Frequency Contribution Factors Procedure

Final Report – Standard consultation
for the National Electricity Market

Published: 1 June 2023

Figure 1 Occurrence of 4-second intervals when FDs >15 mHz and FM > 0

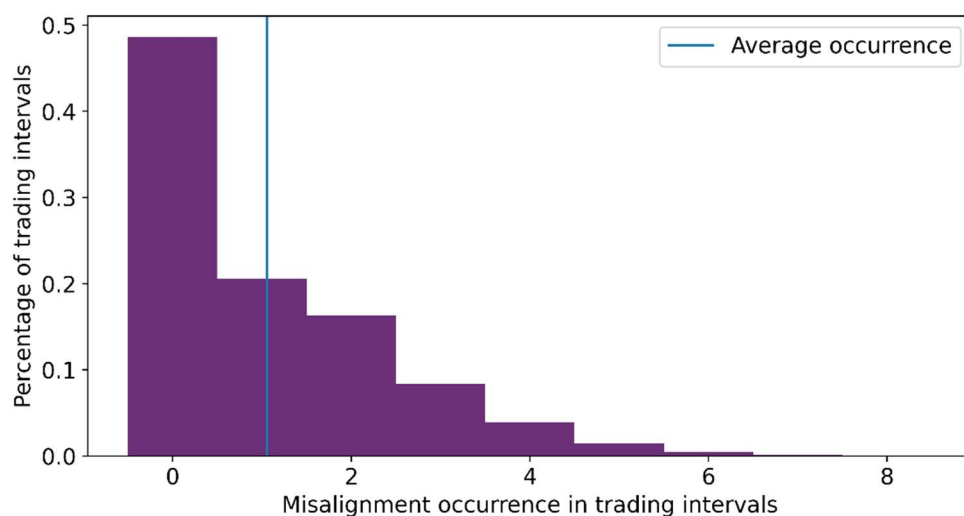
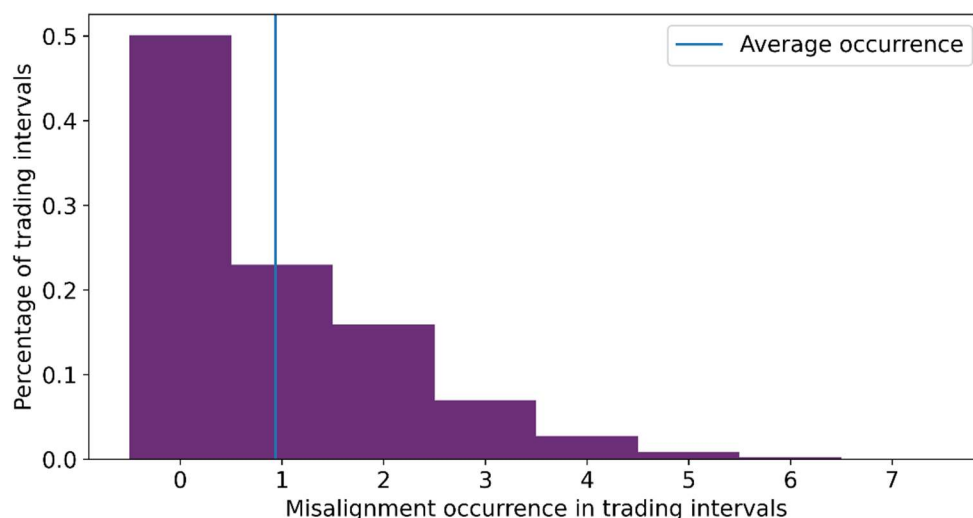
We would also like to raise what we consider to be a third secondary condition for AEMO's consideration. Data provided to AEMO technical workshop on 21 February 2023², indicated that at times the proposed EMA measure is misaligned with actual power system frequency which is the physical metric that generating units or scheduled loads providing PFR respond to. This results in a financial distortion of the physical signals which incentivise the provision of PFR. This is similar to the current issue in the CF calculation where at times the Frequency Indicator (FI) is misaligned with power system frequency. Currently where FI and power system frequency are misaligned the trading interval is removed from the CF calculation. We recommend that the draft procedure be amended to record a Null value for those 4 second intervals when misalignment between the frequency measure and measured power system frequency occur.

AEMO notes that there is potential for the FM and FDs to indicate opposite needs to raise/lower power system frequency.

To understand how often this occurs on average, AEMO conducted an analysis on historical power system frequency data. Figure 1 and Figure 2 respectively show the percentage of trading intervals for different numbers of misalignments when frequency is higher and lower than 50 Hz.

Nevertheless, AEMO agrees with Shell Energy’s and AEC’s suggestions to ignore the 4-second intervals (i.e., set the 4-second performance value to zero) when there is a misalignment between the FM and FDs only where the raw frequency is outside the PFCB in the opposite direction from the FM. This should ensure that generating units correctly providing PFR are not penalised. An example of such cases is shown in Figure 3, where the 4-second performance values of a unit are set to zero at 4-second intervals where there is a misalignment between the FM and FDs (these intervals are highlighted in the figure).

AEMO will exclude the 4-second intervals where there is a misalignment between FM and FDs, and the frequency is outside the PFCB in the opposite direction from the FM.

Figure 3 Impact of ignoring 4-second intervals where the FM and FDs are misaligned

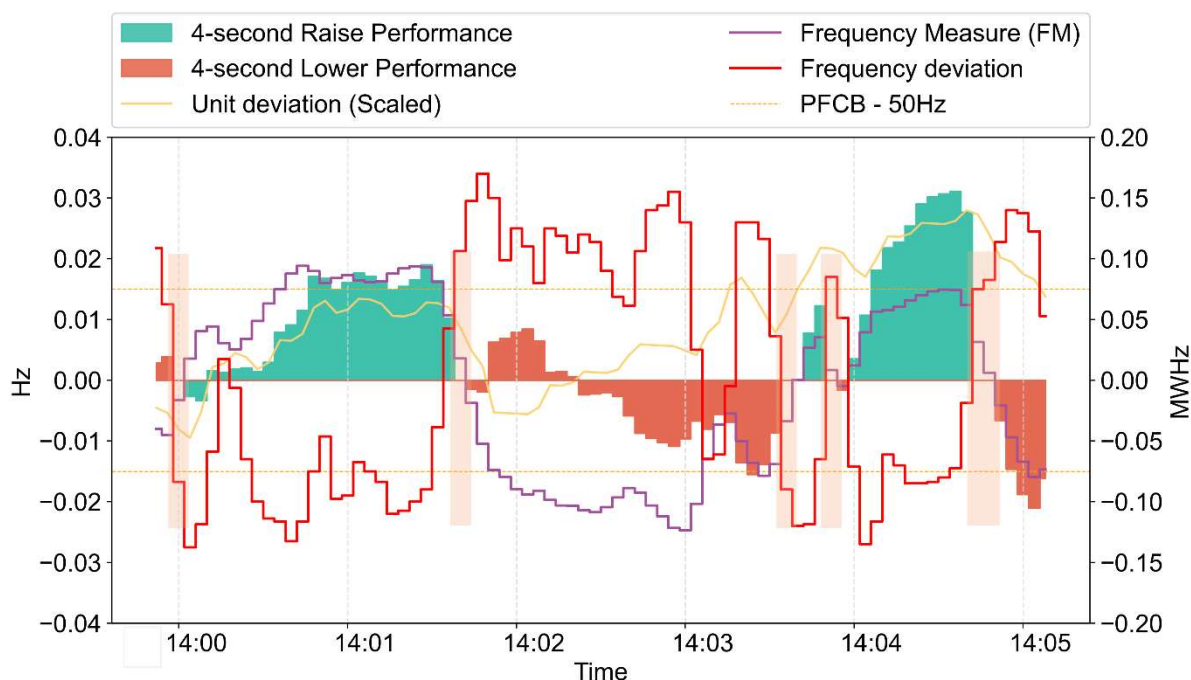
Given that it is a moving average, there will be instants where the actual frequency has crossed to one side of 50Hz whilst the measure is still on the other side. Those DUIDs who have responded very quickly to that frequency change will be anomalously briefly penalised by the measure. AEMO has argued that this anomaly has low materiality, which the AEC does not dispute. However, as a matter of principle, AEMO should consider whether it is appropriate and feasible to at least zero the penalty for these instants.

Figure 4 Unit-level analysis of the FPP net settlement of regulation-enabled units

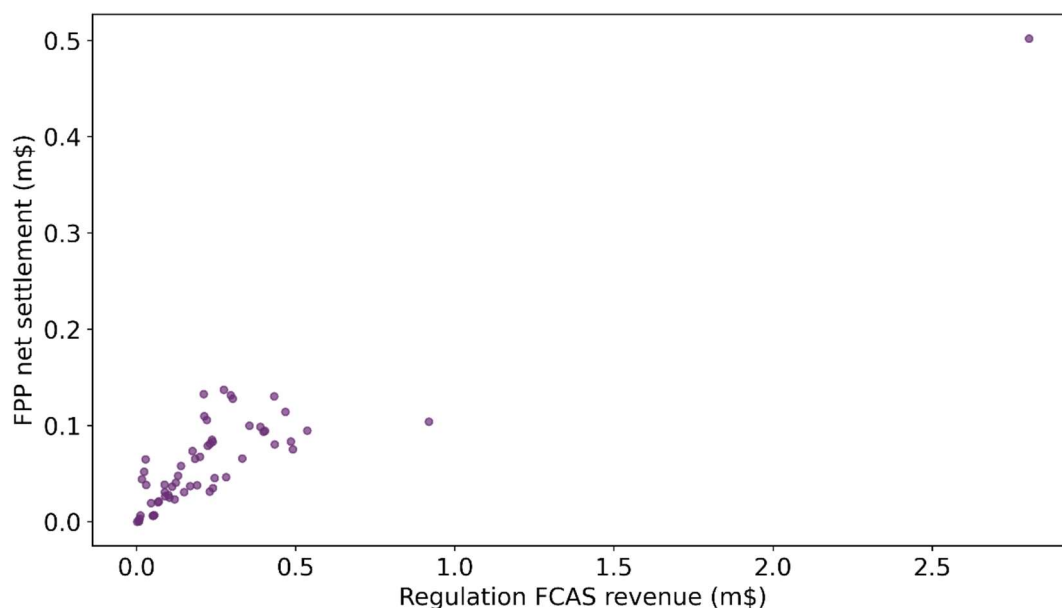
When eligible units are enabled to provide Regulation FCAS and required to follow AGC setpoints, it is true they may be assigned negative performance based on their real-time impact on power system frequency. Following the AGC signal could result in a 5-minute negative performance when the frequency indicator (FI) and FM do not align in most of that trading interval, which results in the unit’s deviations not helping real-time frequency.

Supporting this, a new unit-level analysis depicted in Figure 4 shows a strong positive correlation between FPP net settlement and Regulation FCAS revenue of regulation-enabled units in the mainland during the intervals they were enabled to provide either global or mainland Regulation FCAS. The new findings reinforce the conclusion from previous analysis that regulation-enabled units tend to receive positive FPP net settlements.

In light of these observations, AEMO considers that using different types of trajectories for different types of Regulation FCAS providers (AGC vs non-AGC, Regulation FCAS enabled vs not enabled, different technologies, etc) will create complexities and cost without yielding commensurate benefits. Additionally, AEMO notes that Regulation FCAS providers may factor in the possibility of a negative FPP, in addition to other factors, when submitting their Regulation FCAS bids.
